Ref: 2107 Hawkesbury CoE

RE: BUSHFIRE REVIEW – HAWKESBURY CENTRE OF EXCELLENCE

Project
Centre of Excellence in Agricultural Education
at
HAWKESBURY

Drawing Title
Proposed Site Plan

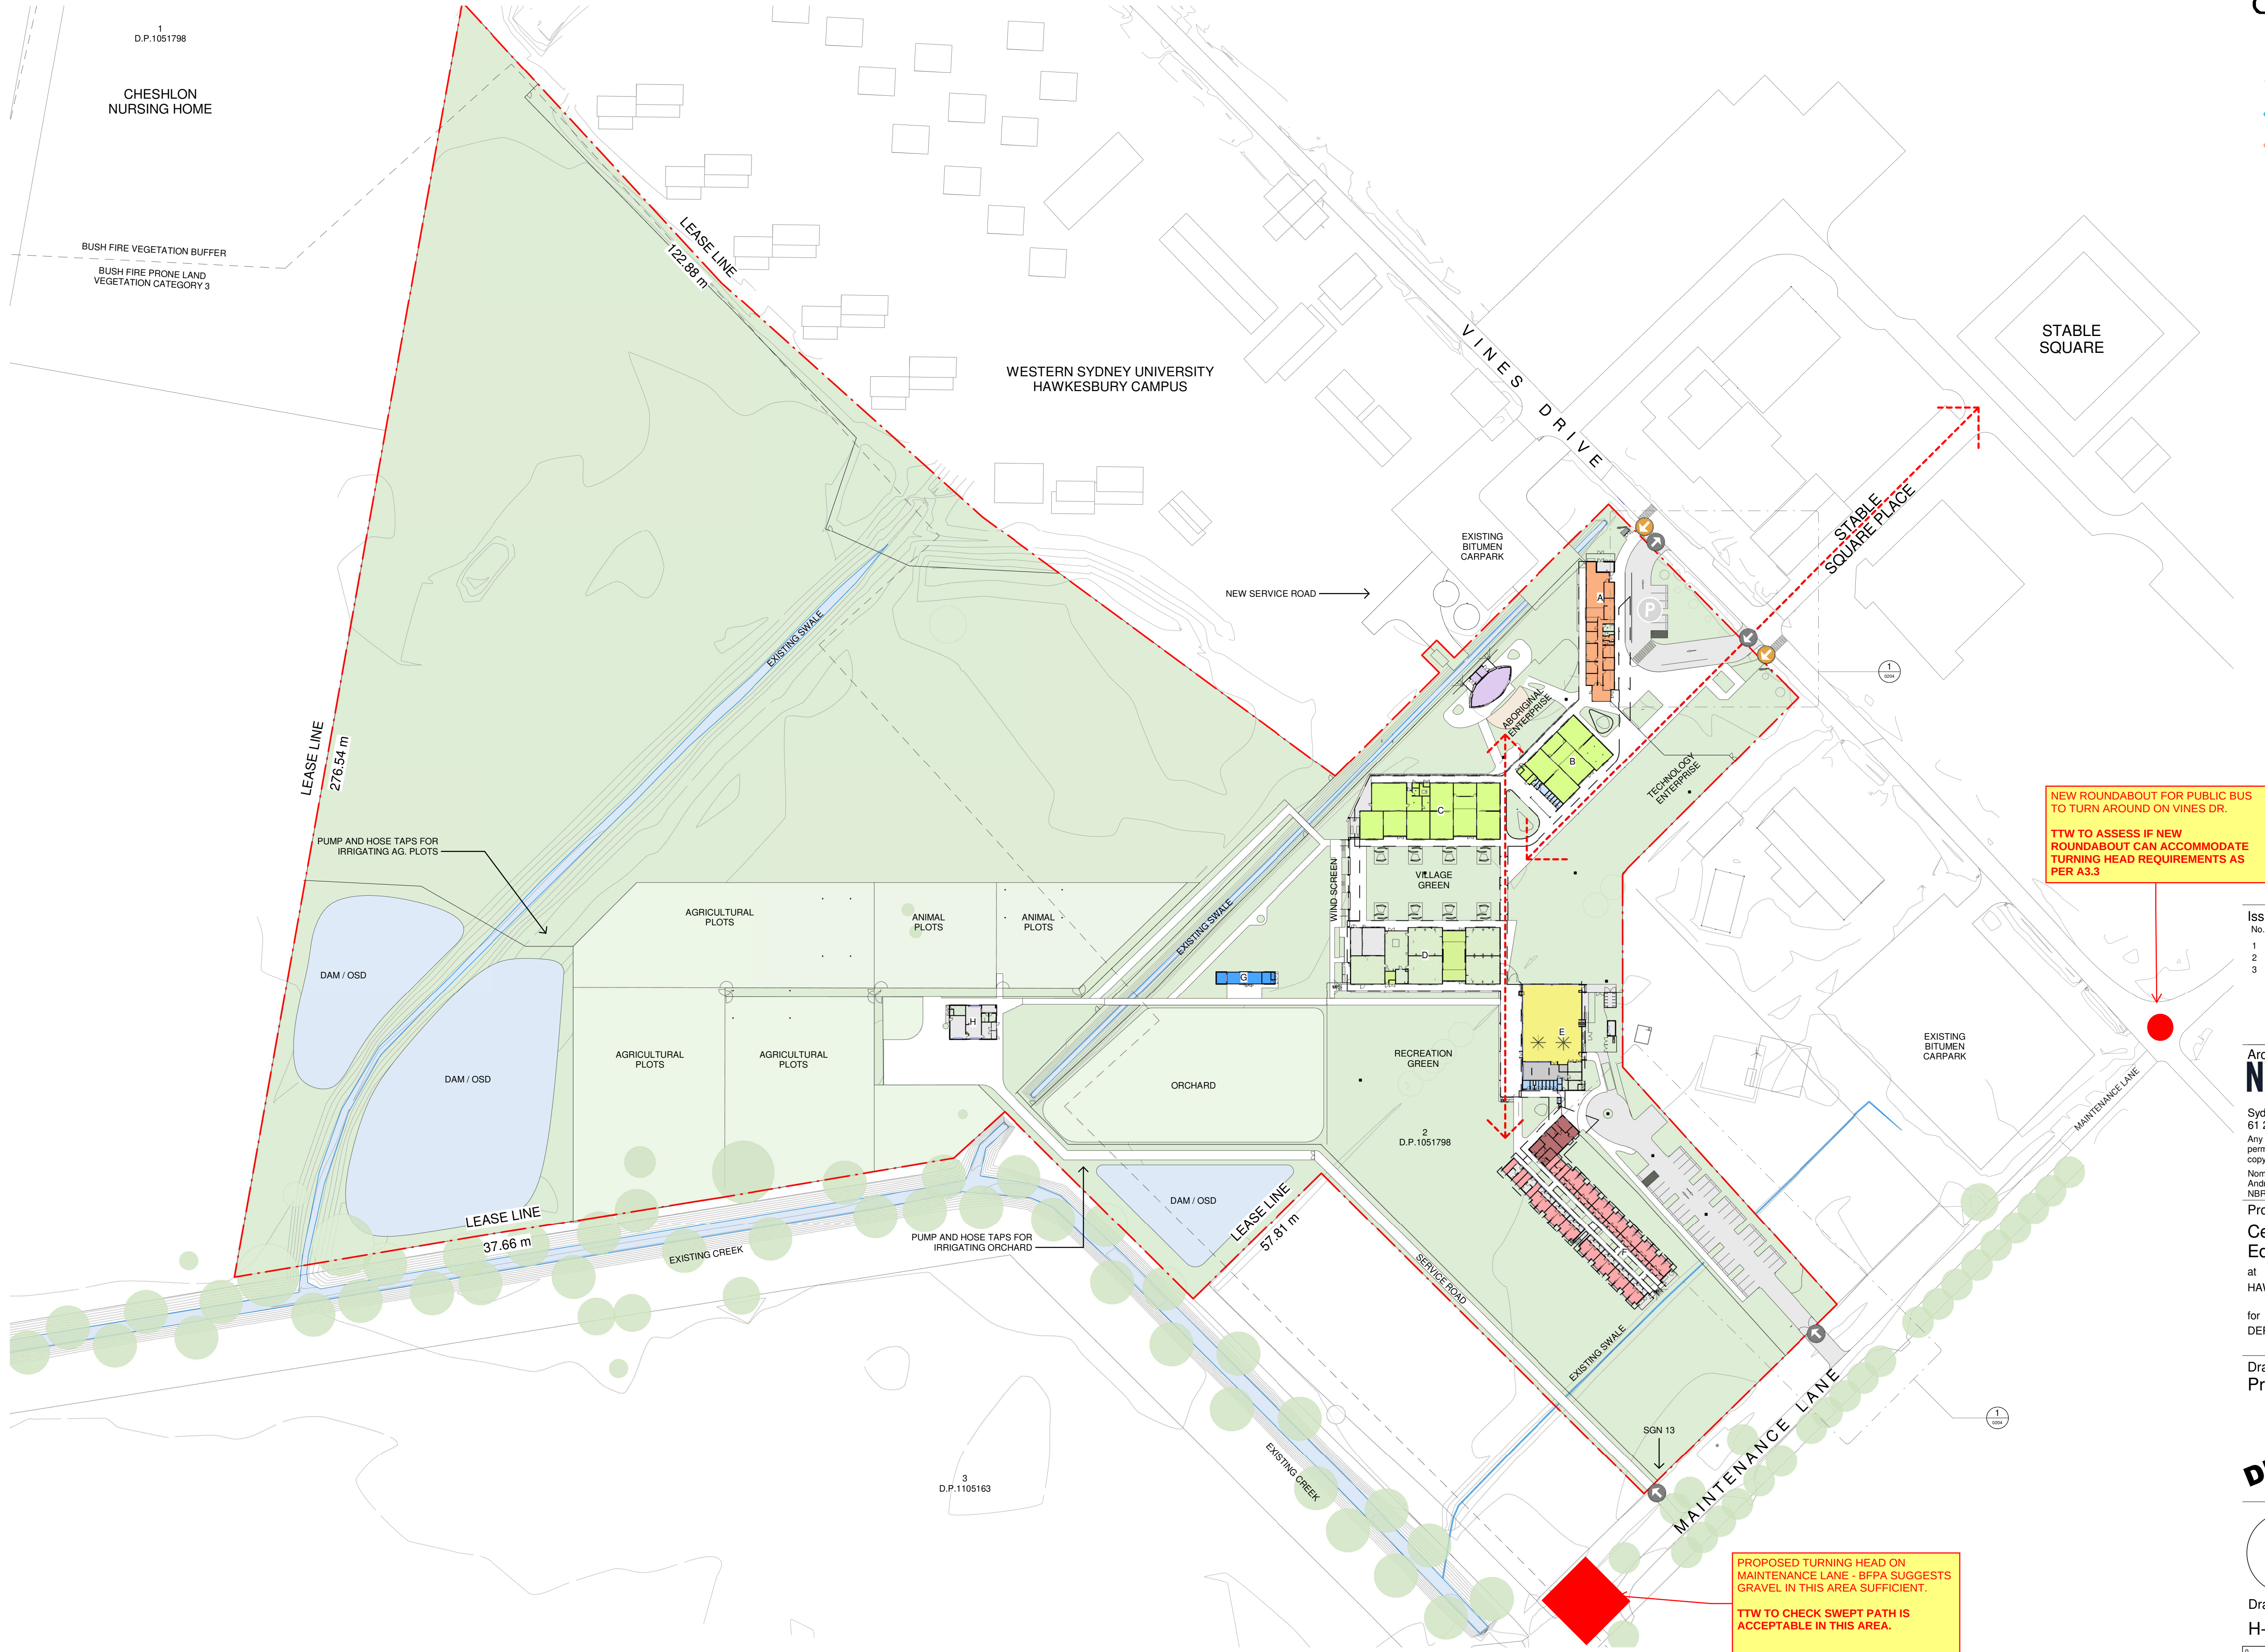
Attachment A demonstrates the section of Vines Drive up to the intersection of Maintenance Lane will be increased to 7m in width to facilitate the movement of public buses. In addition, a new roundabout will be constructed at the intersection of Vines Drive and Maintenance Lane to facilitate the turning around of a public bus. An additional turning area will also be provided at the southwestern end of Maintenance Lane.

DRAWING TITLE
VEHICLE MANOEUVRE

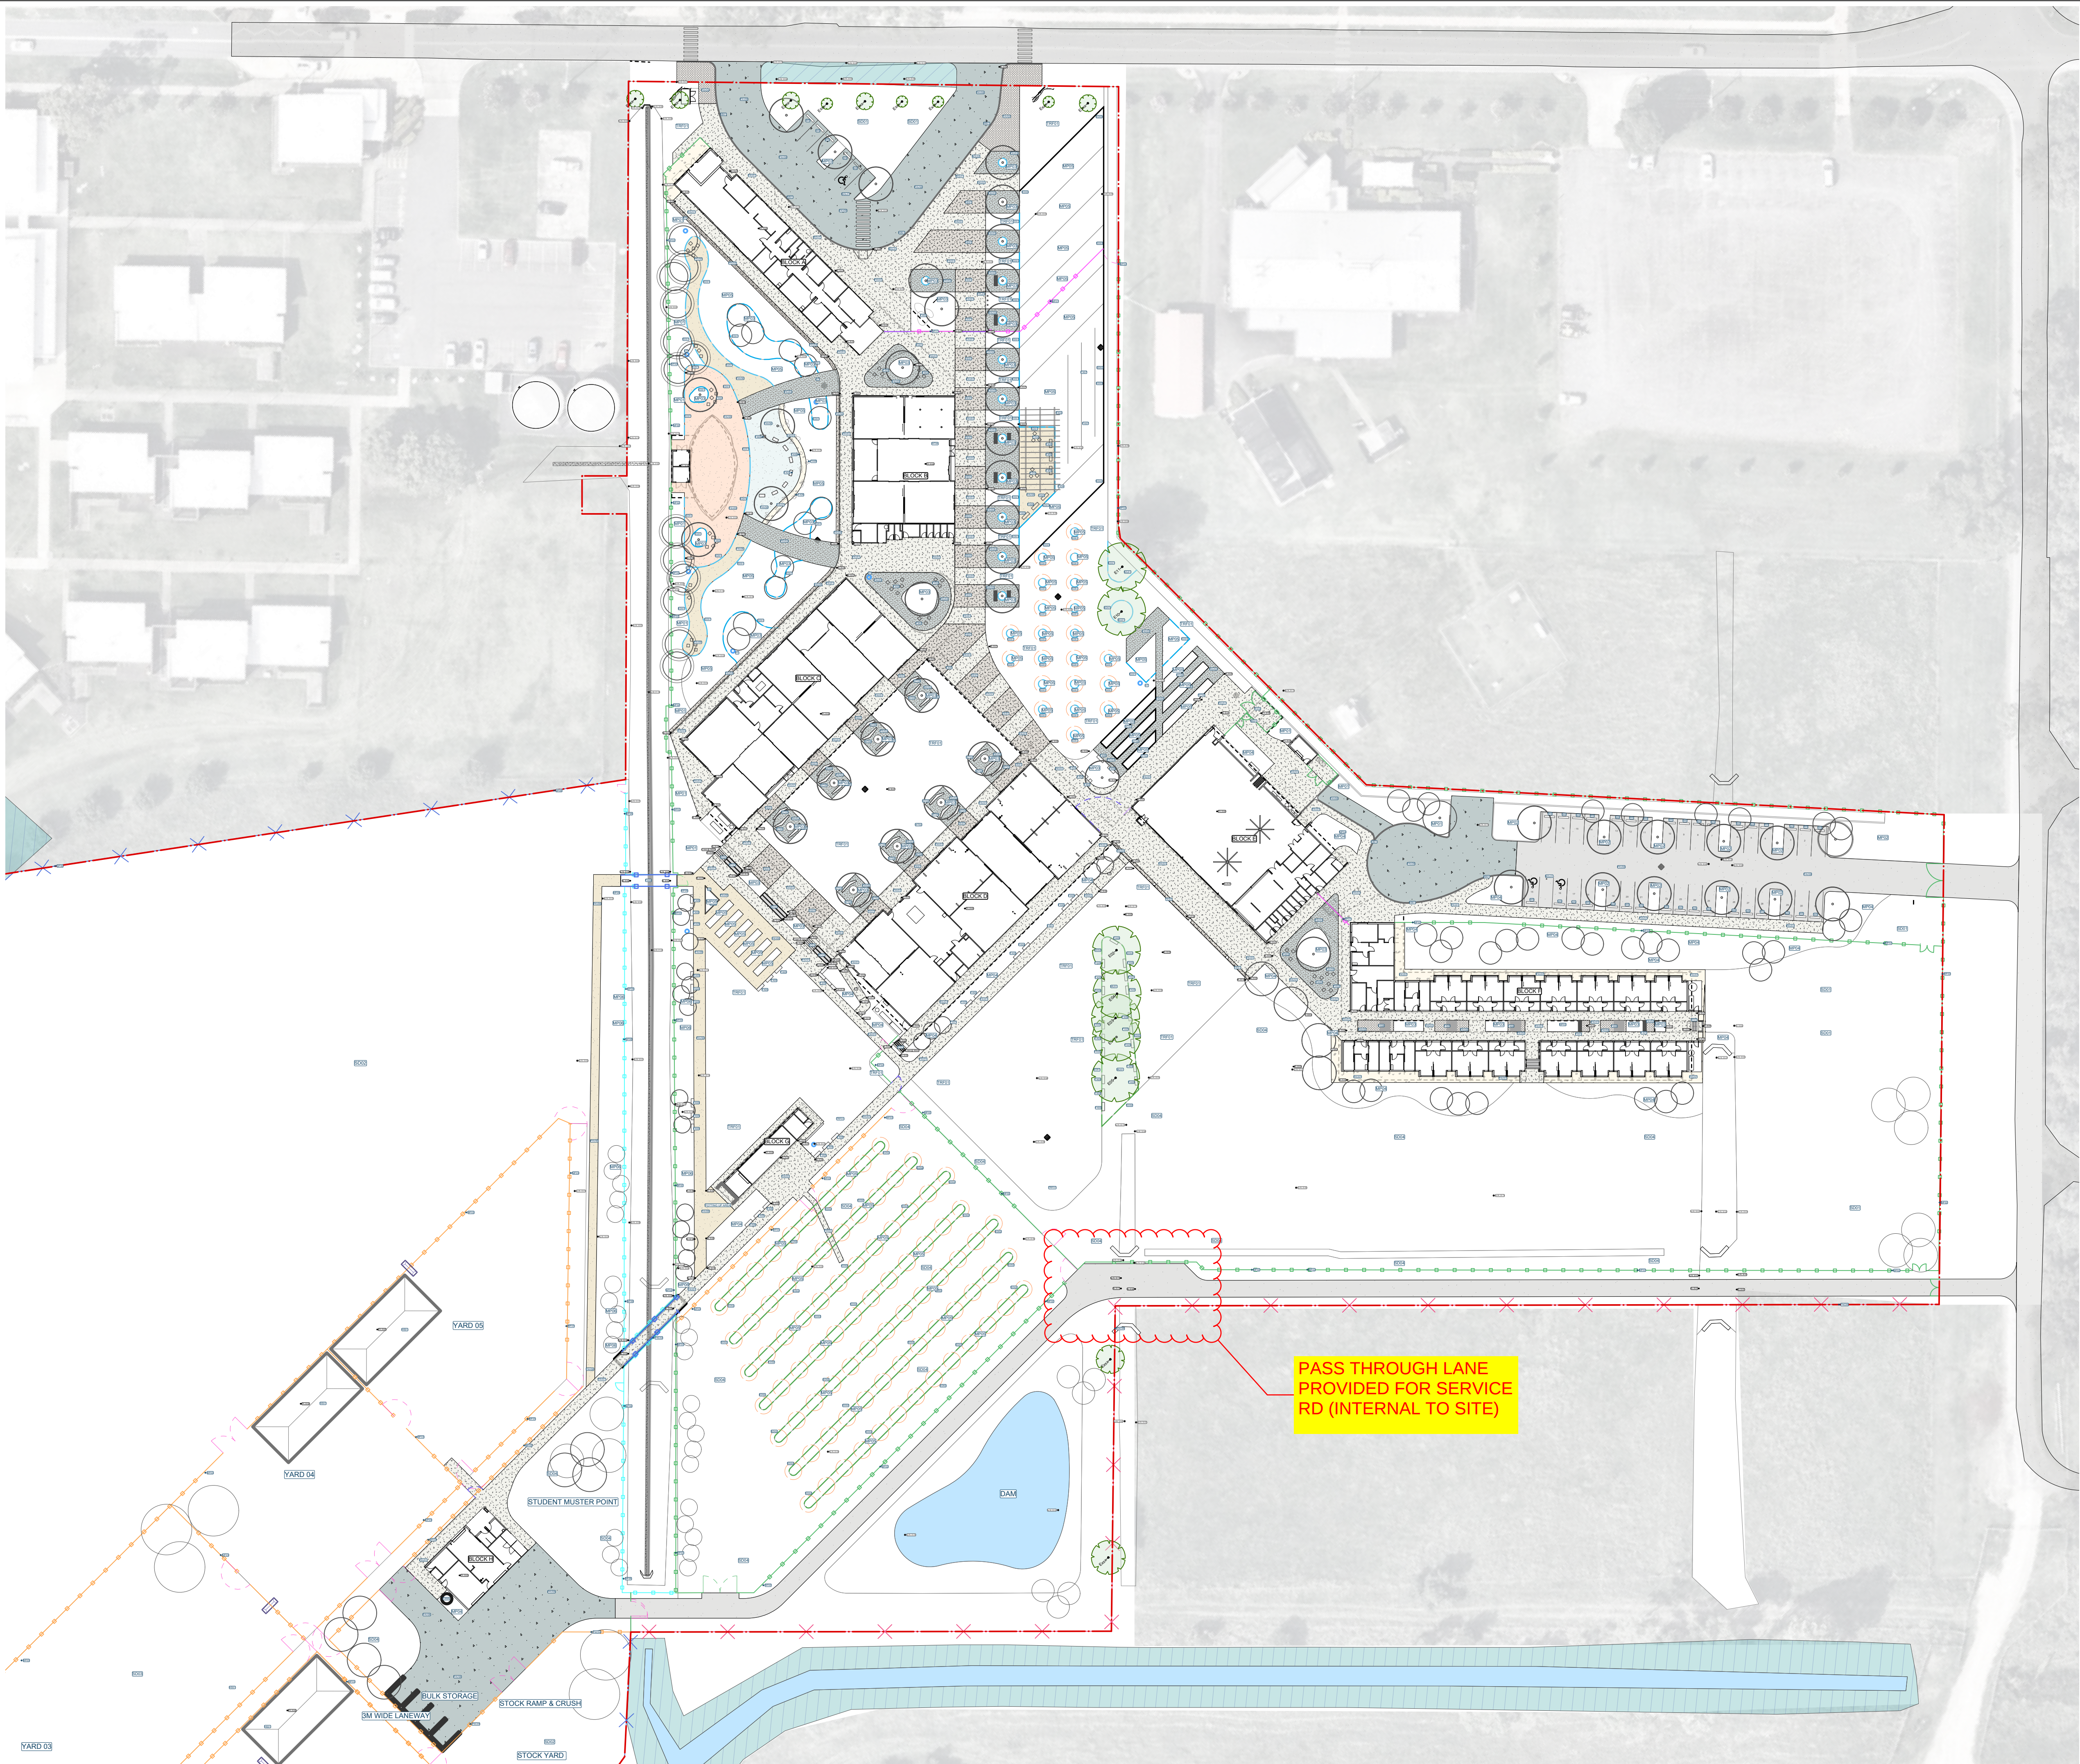
The service road to the agricultural and animal plots is not a high traffic volume public road. It is intended for deliveries and transporting materials. *Attachment B* indicates a passing bay 20m long will be provided at the corner between the dam and the orchard to increase the total width of the road to 6m for 20m. The service road traverses along managed recreational areas and an orchard. The fire hazard is considered to be low and the need to suppress a fire in this area is deemed to be rare.
